Fluidic Device Design for the APR1400

APR1400-Z-M-TR-12003-NP-A

SUBJECT: ADVANCED POWER REACTOR 1400 FINAL SAFETY EVALUATION
FOR TOPICAL REPORT APR1400-Z-M-TR-12003-P, REVISION 0,
“FLUIDIC DEVICE DESIGN FOR THE APR1400”

Figure RAI-10 A schematic diagram of the SIT-FD

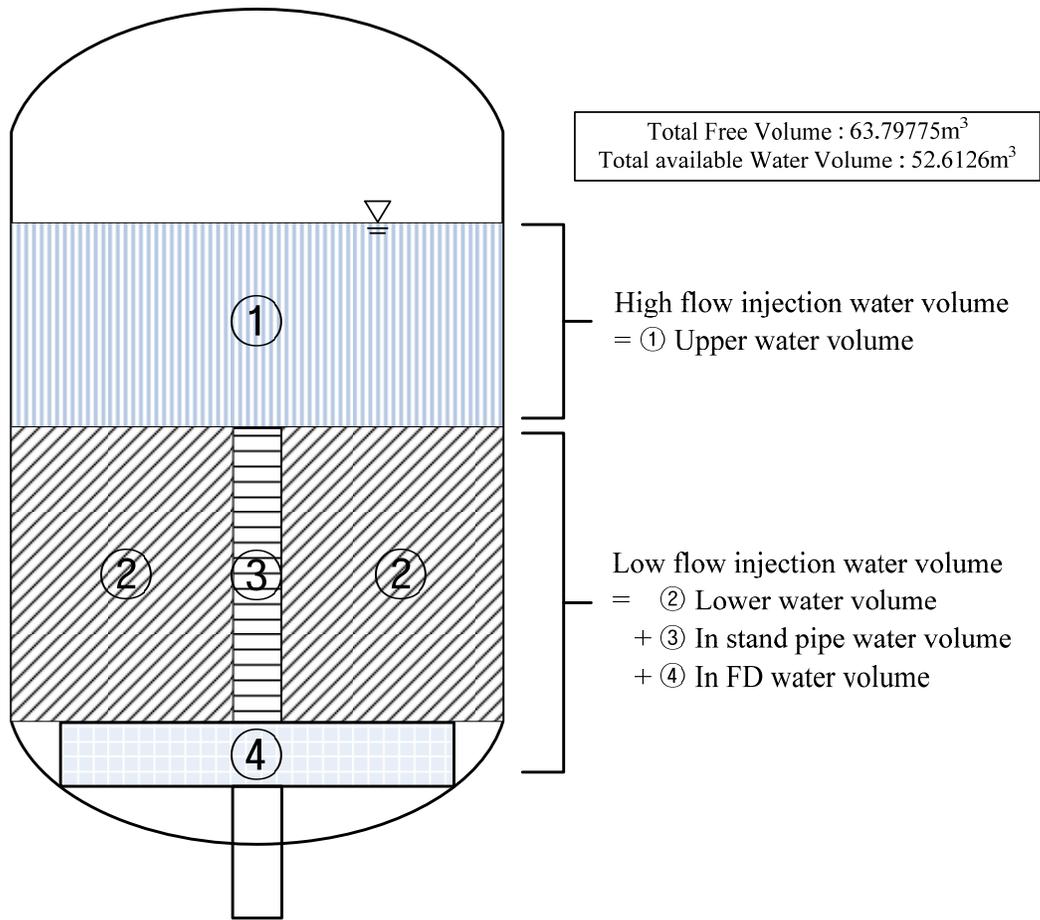
Figure 4.3-1 and 4.3-2 show the flow rate turning point (around 30 seconds) when the SIT water level (after subtracting [^{TS}]) is close to the stand pipe level.

The results of SIT-FD model assessment against VAPER tests show that the SIT-FD model described above reasonably predicts flow rate turning time from large flow injection phase to small flow injection phase. The details of SIT-FD model assessments are described in Appendix H of TR CAREM.

Table 5.2-2 N₂ Solubility (kg/kg_{water}) in Pure Water at 40 °C (104 °F)

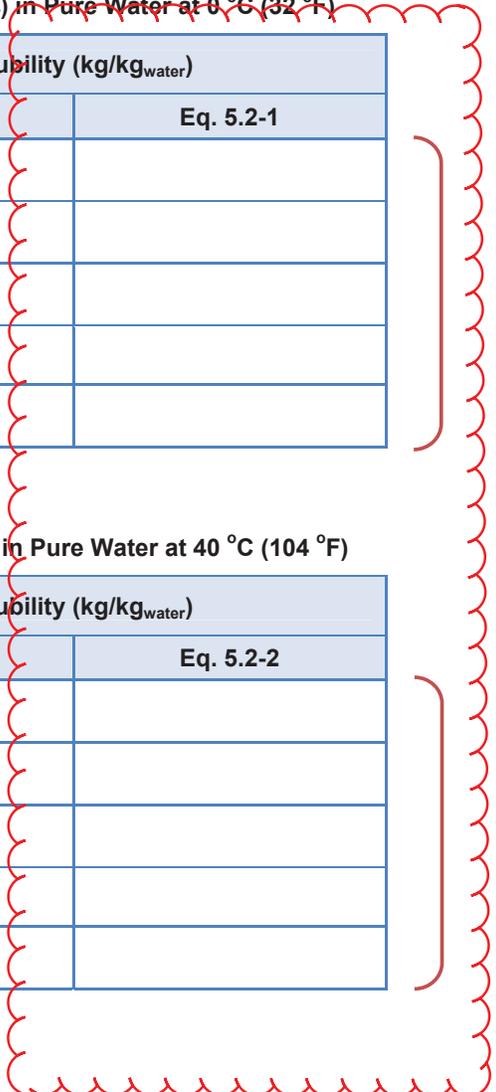
The staff identified a discrepancy in Table 5.2-1, "N₂ Solubility (kg/kgwater) in Pure Water at 0 C," and in Table 5.2-2, "N₂ Solubility (kg/kgwater) in Pure Water at 40 °C" (Reference 1). Both tables contained errors in the calculated nitrogen solubility. Therefore, on March 30, 2015, the staff had a clarification phone call with the applicant regarding the errors discovered in the tables. Subsequently, the applicant submitted a revised response to RAI 2-7371, Question 16 (ML15113A290), which corrected the errors in Tables 5.2-1 and 5.2-2. Therefore, RAI 2-7371, Question 16, is being tracked as a confirmatory item pending the incorporation of the corrected nitrogen solubility calculations into Table 5.2-1 and Table 5.2-2 (Reference 1).

The nitrogen solubility numbers in the far right column of Table 5.2-1 are obviously typos. However, we confirmed that the curve fitted equations of 5.2-1 and 5.2-2 were correct, and the nitrogen gas release rate (Fig. 5.2-1 and 5.2-2) were correctly calculated from the equations of 5.2-1~5.2-4. The topical report will be revised replacing Table 5.2-1 and 5.2-2 with corrected tables as shown in attachment.
